BT20-010

2016-2017 Q50; RUST ON TRUNK LID ABOVE INNER REAR COMBINATION LAMP

APPLIED VEHICLES: 2016-2017 Q50 (V37)
 2016-2017 Q50 Hybrid (VH37)
APPLIED DATE: Built before April 24, 2017

Figure 2

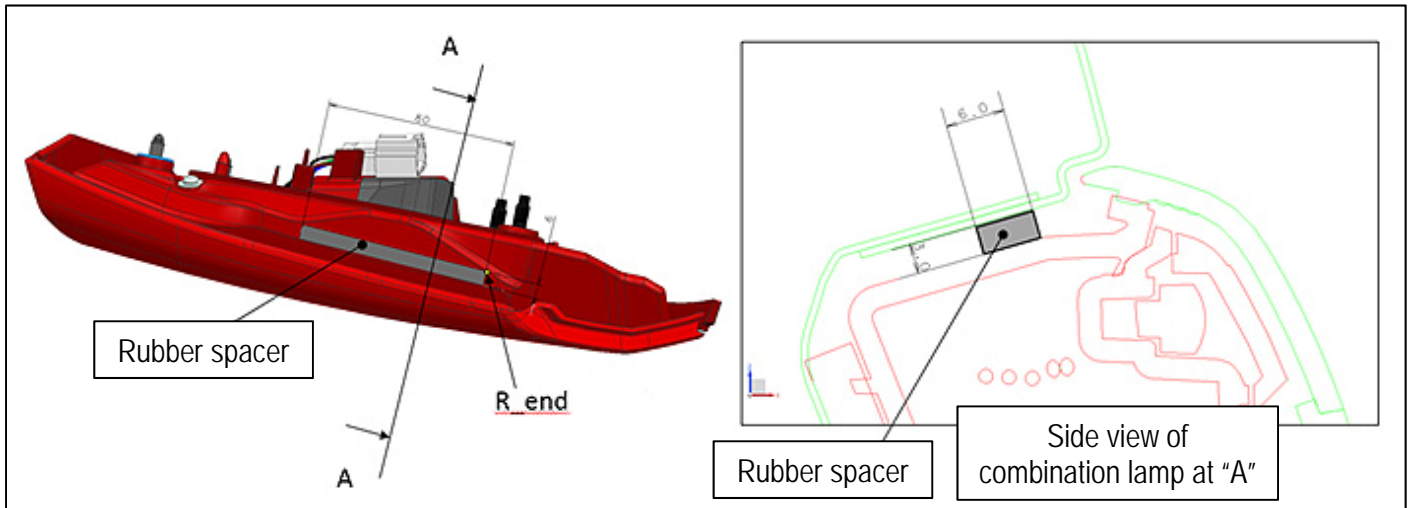
1. Remove the rear combination lamps from the trunk lid.
 - For the procedure to remove the combination lamps, refer to the Electronic Service Manual (ESM): section **DRIVER CONTROLS > EXTERIOR LIGHTING SYSTEM > LED HEADLAMP > REMOVAL AND INSTALLATION > REAR COMBINATION LAMP**.
2. Repair the trunk lid finish as needed.
3. Apply one (1) rubber spacer onto the top of each combination lamp in the area shown in Figure 2.
 - See the **PARTS INFORMATION** on page 3.

Figure 3

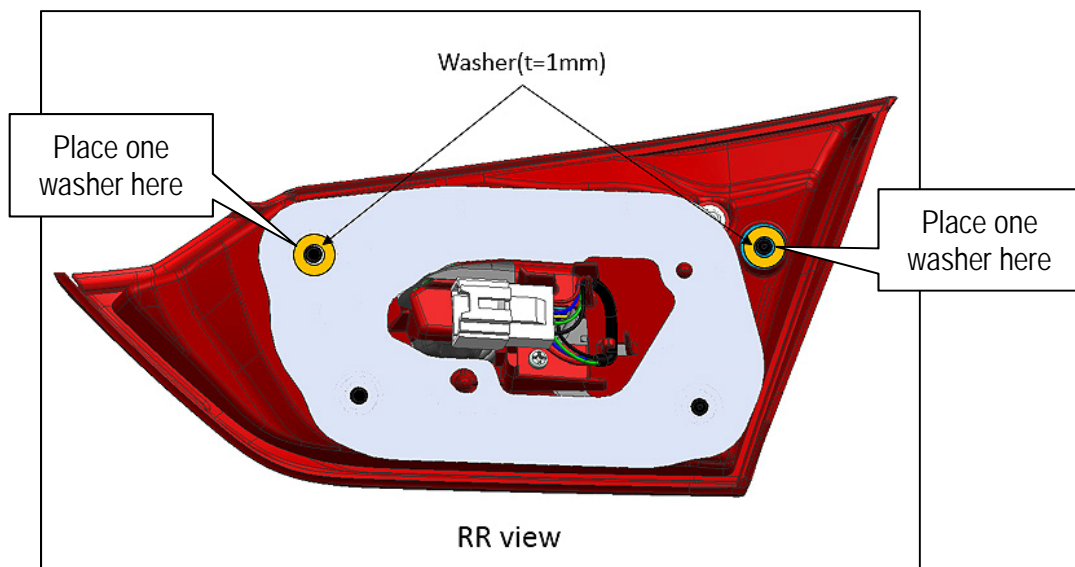
4. Add two (2) washers to each combination lamp; one (1) to each threaded stud where shown in Figure 3.
